CONSTRUCTION OF NEW MUNICIPAL SOFTBALL PARK REBID

PROJECT NO.: 08-18-C28-608

A D D E N D U M NO. 1

ADDENDUM No 1
SOFTBALL FIELD FACILITIES
MUNICIPAL PARK
McALLEN, TEXAS

1

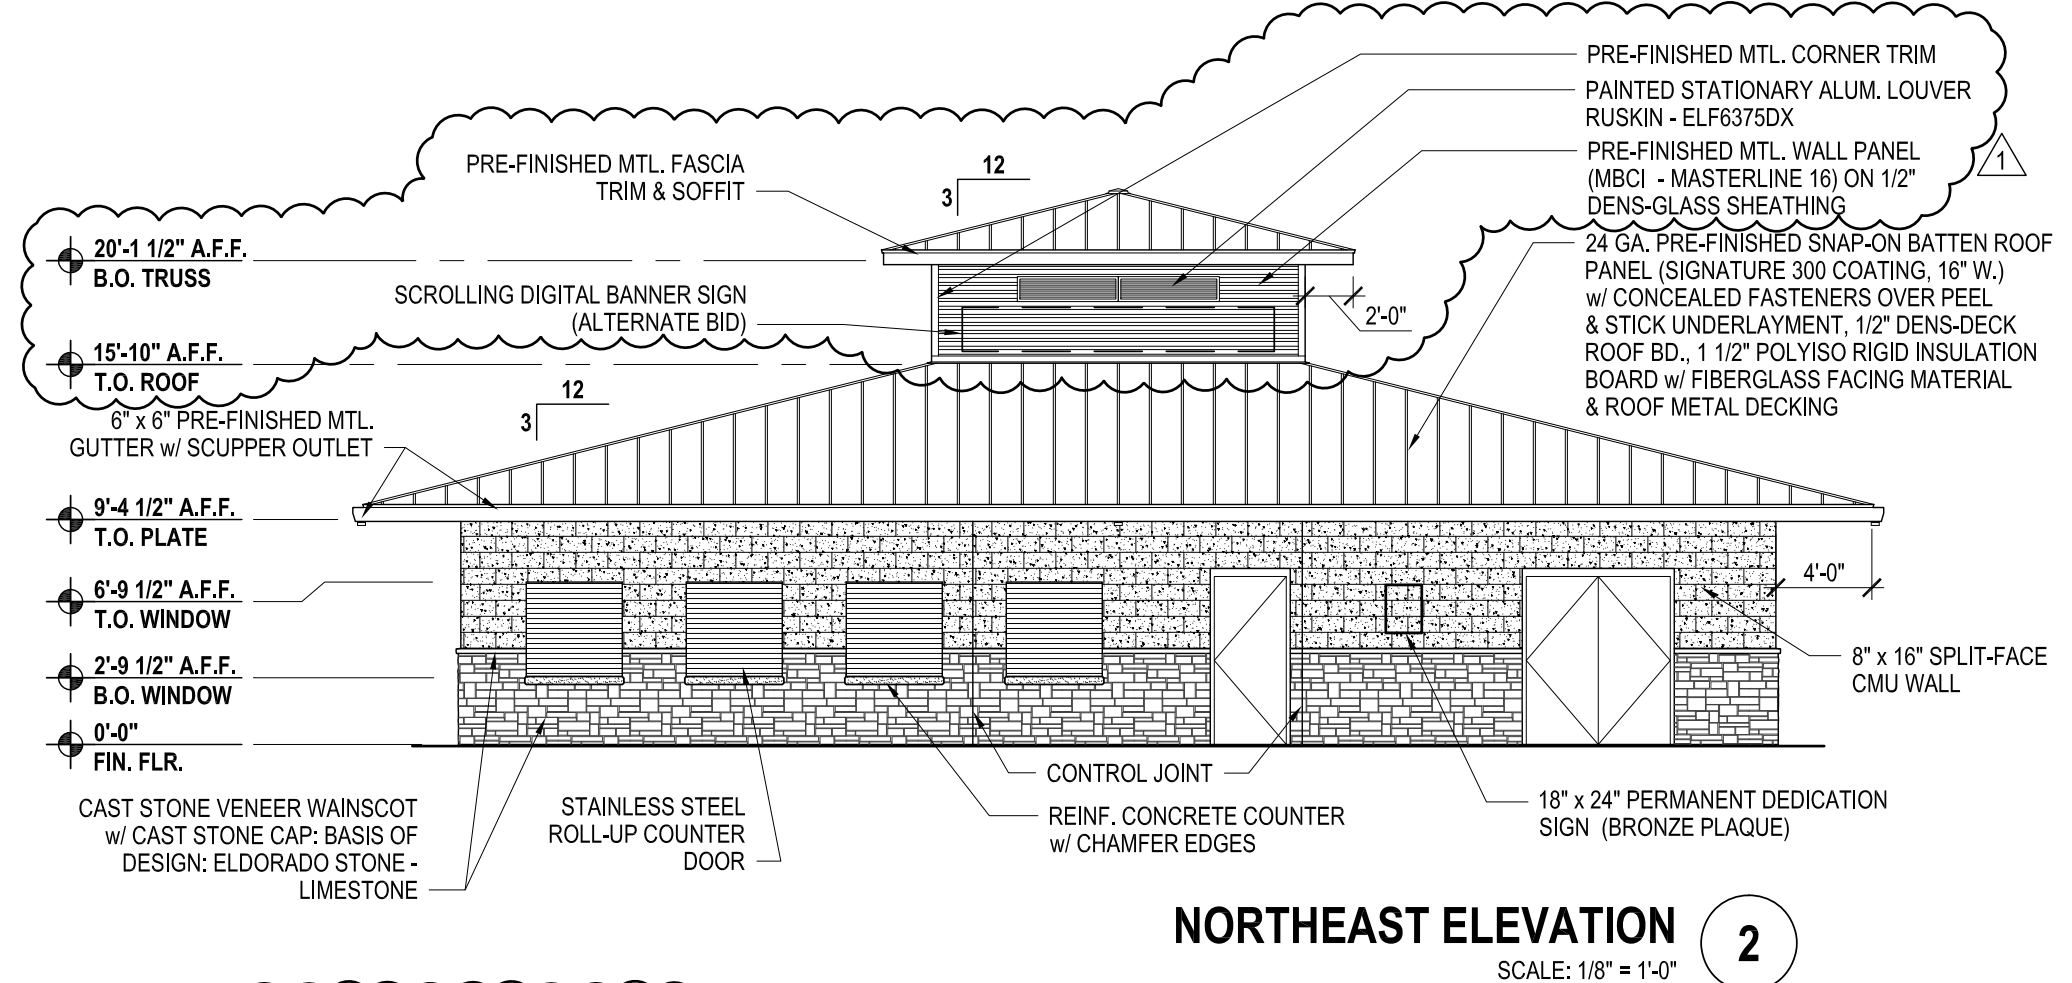
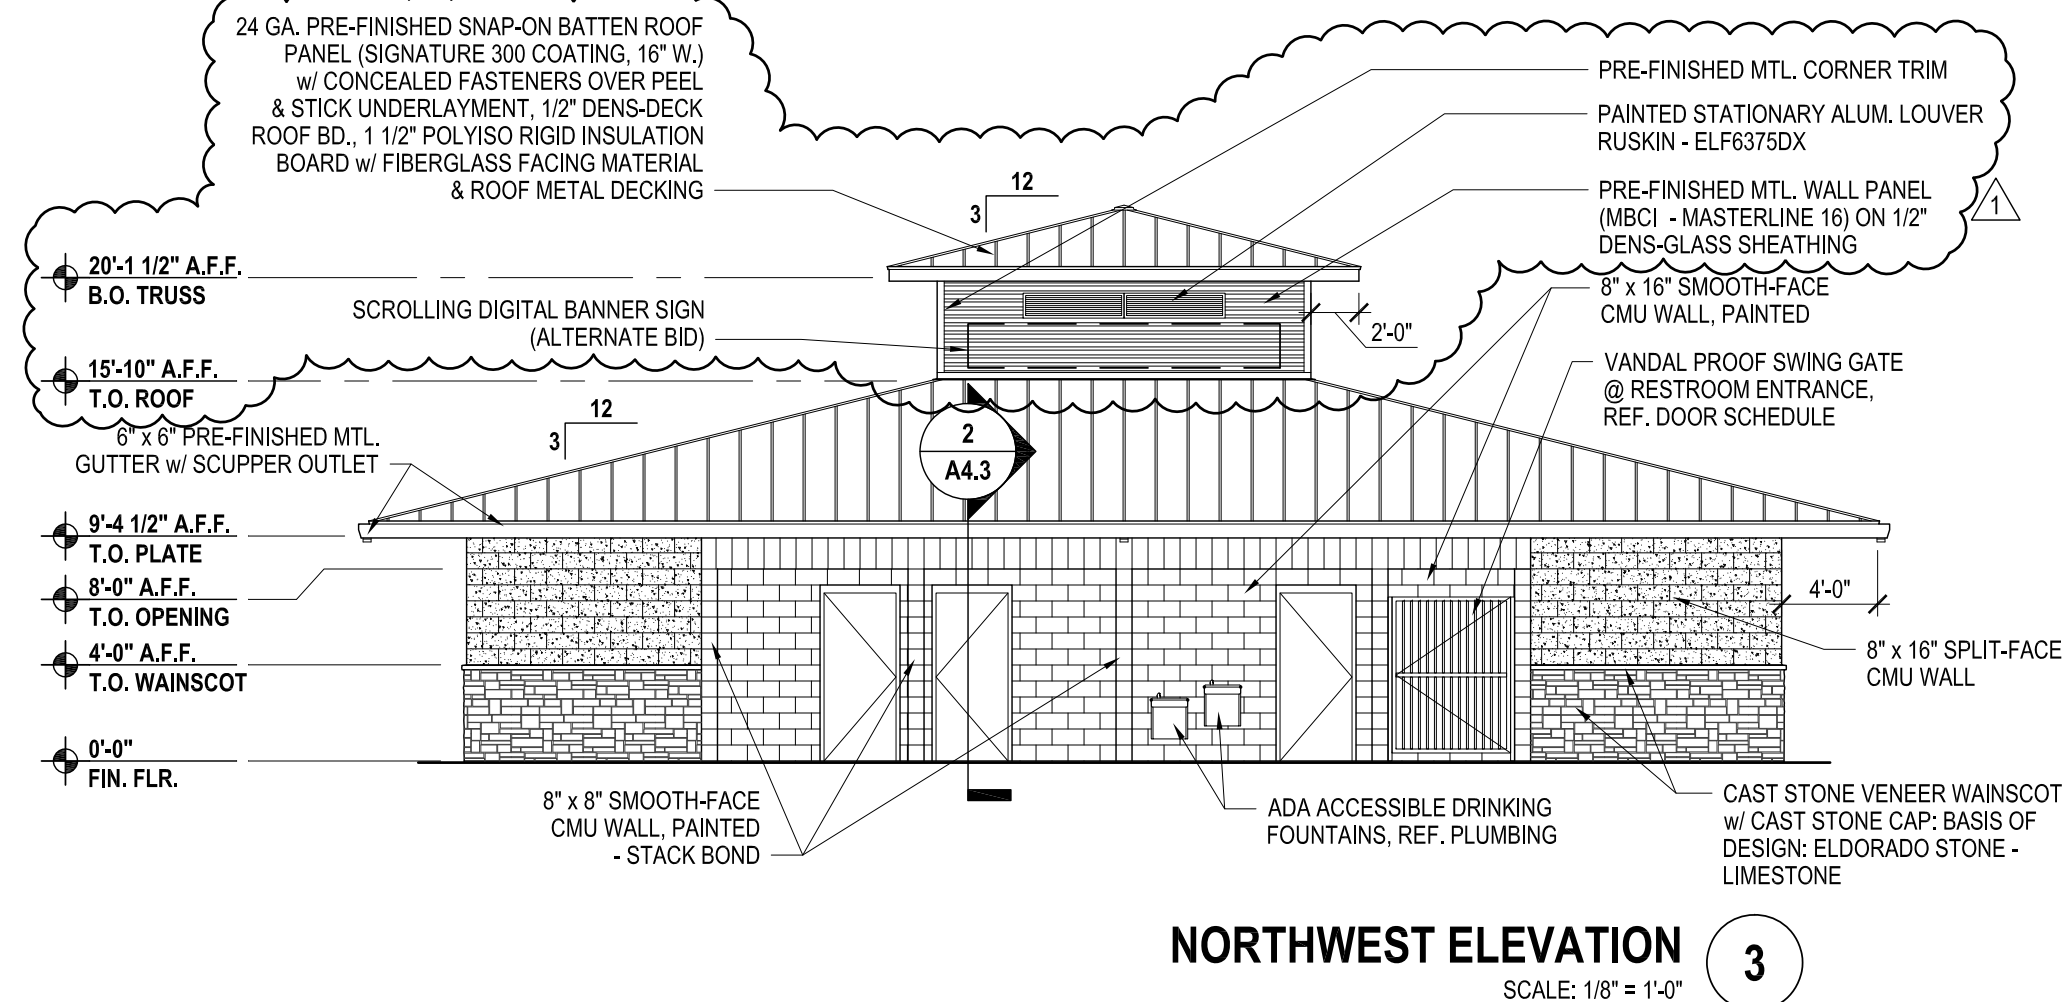
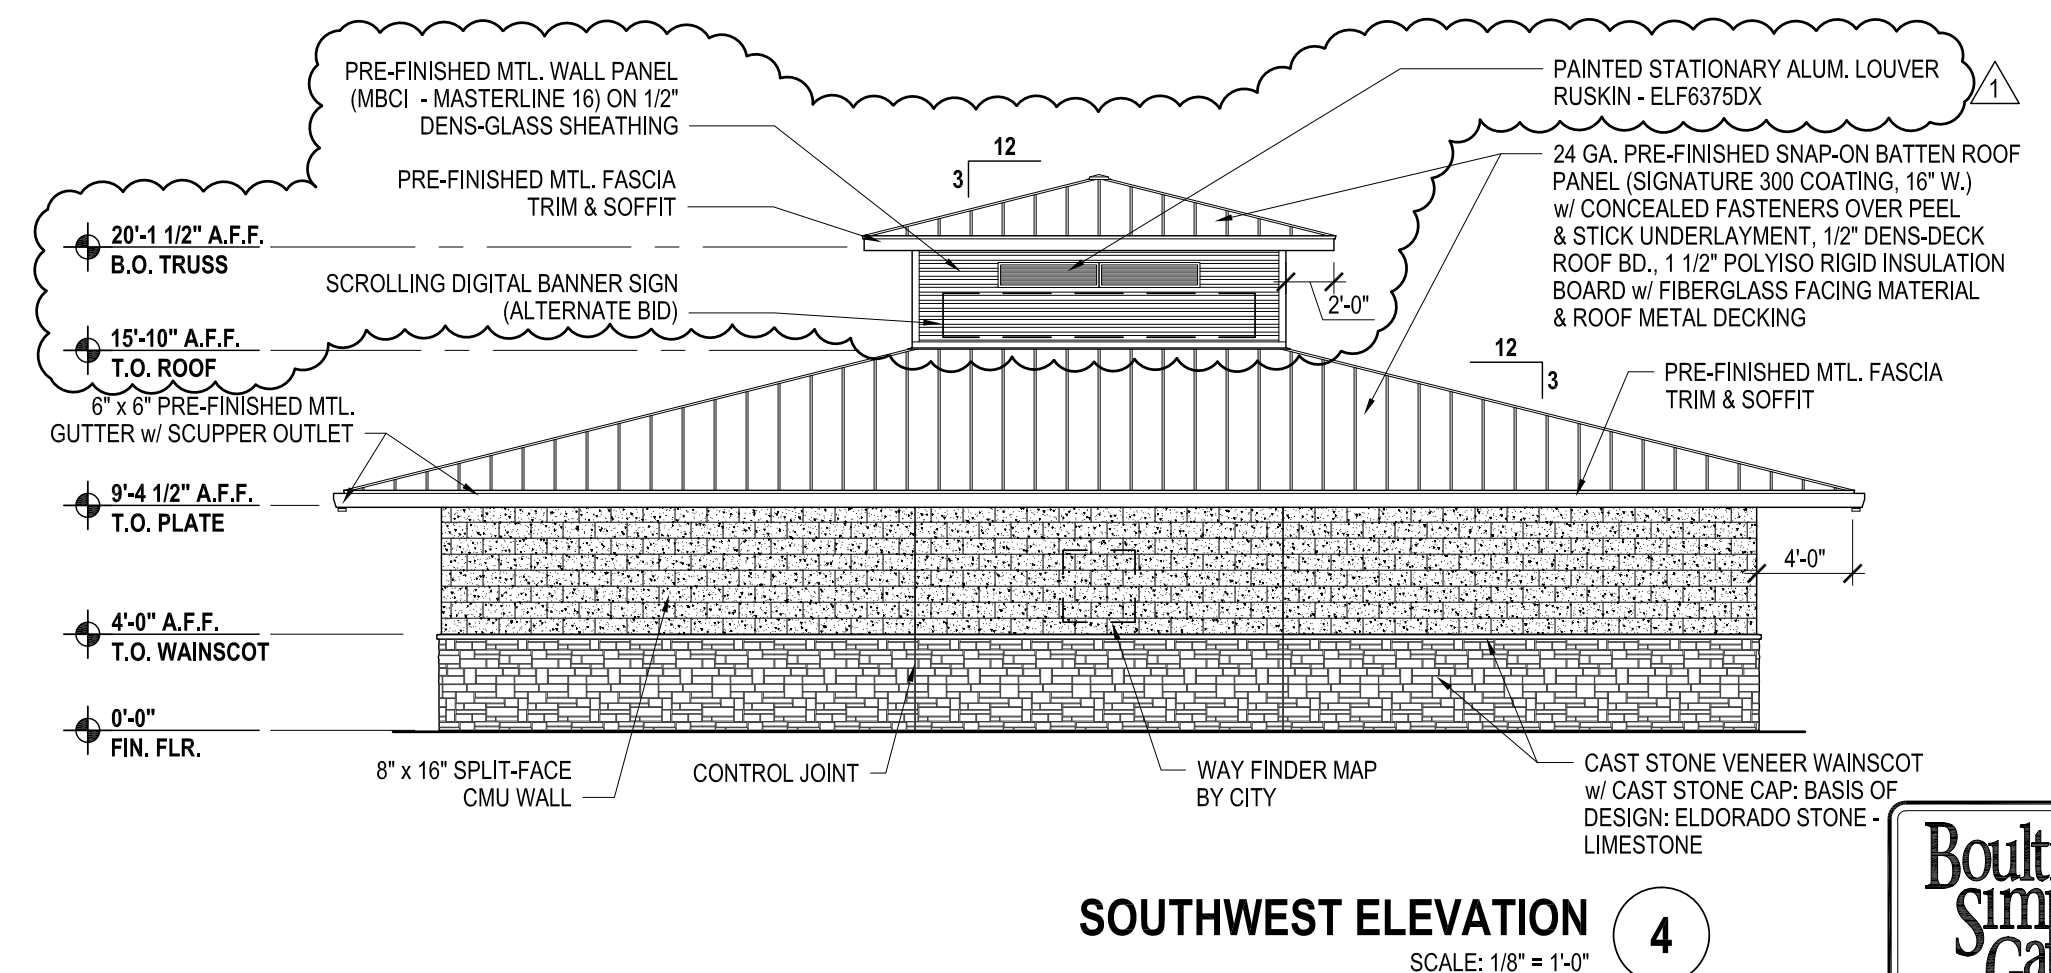
- A2.1 Added outline of Cupola wall above. Added RCP key note #7 & revised key note #8.
- A2.2 Relocated ADA urinal, added ADA notes & dimensions.
- A2.3 Relocated ADA urinal, added ADA notes & dimensions.
- A3.1 Added Cupola & material call outs.
- A4.1 Added wall section at Cupola. Added ADA notes & dimensions.
- A4.2 Added wall detail at Cupola.
